HANNI SITE PLAN

Concord Township · Lake County, Ohio

7660 Kellogg Road (parcel 1)

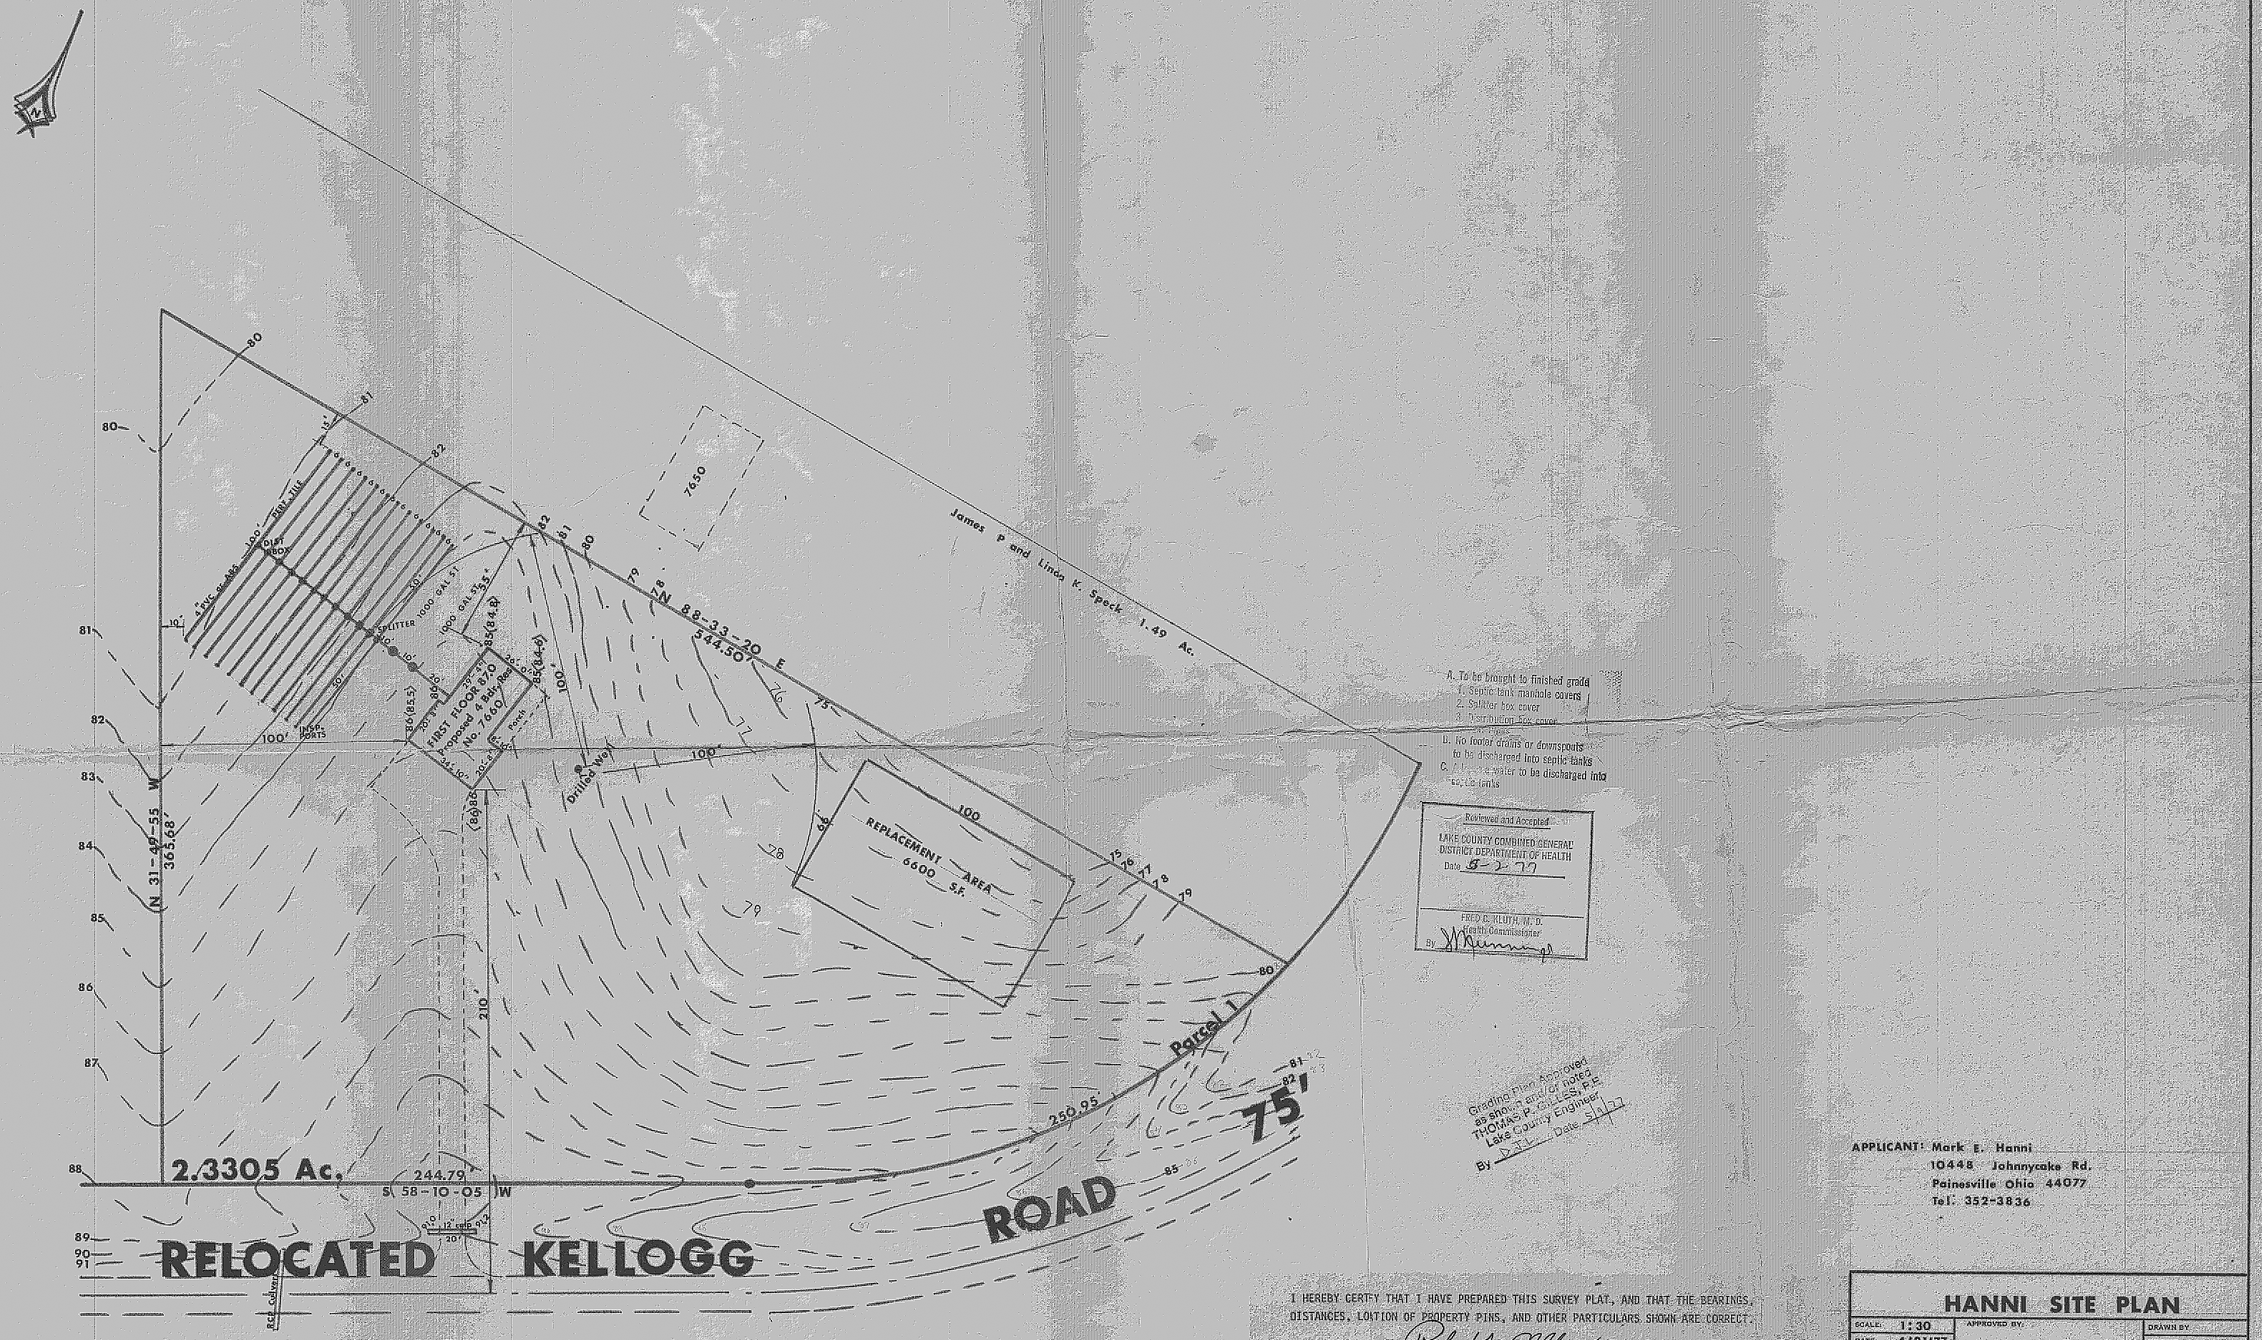
A. To be brought to finished grade
1. Septic tank manhole covers
2. Splitter box cover
3. Distribution box cover

B. No footer drains or downspouts to be discharged into septic tanks

C. [illegible] water to be discharged into septic tanks
